# The Judd Street one-way scheme and Midland Road

Discussion paper by Camden Cycling Campaign, 9th April 2006

## Kings Cross Area Modelling (Buchanans Report for TfL, July 2005)

#### Applied to Option 2 - Buchanans Tables 4.3 and 4.4

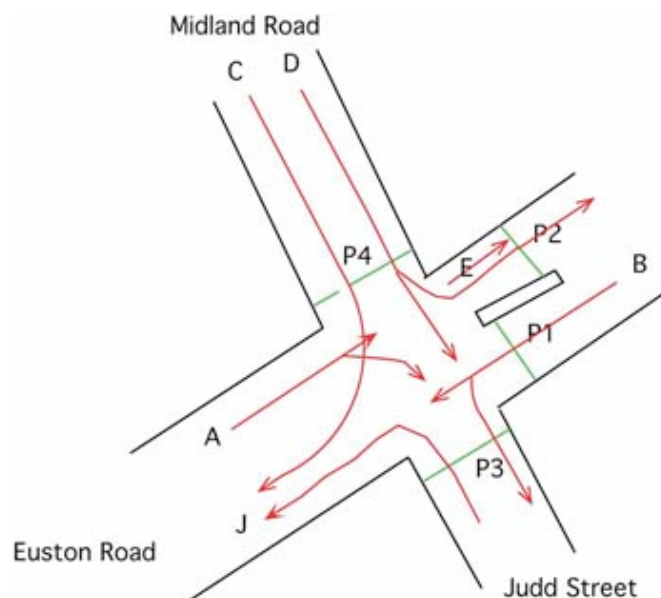
Option 2 allows Judd Street to be 2-way, with a staggered pedestrian crossing. The signals have three stages:

Stage 1 for Euston Road, comprising phases A, B, E, P4;

Stage 2 for Midland Road right turn, phases C, P1, P2, P3

Stage 3 for Midland Road left turn plus Judd Street left turn: phases D, J, E, P1.

We have applied calculations similar to the above. These are shown under the headings 'CCC version of table 4.3 showing effects of reduced flow on signal stages' and 'CCC version of table 4.4 showing effects of reduced flow on signal stages' on page 6. The above colour scheme is used to show the stages of the calculation, which is a little simpler for this option because each phase corresponds to a single stage in the signals.
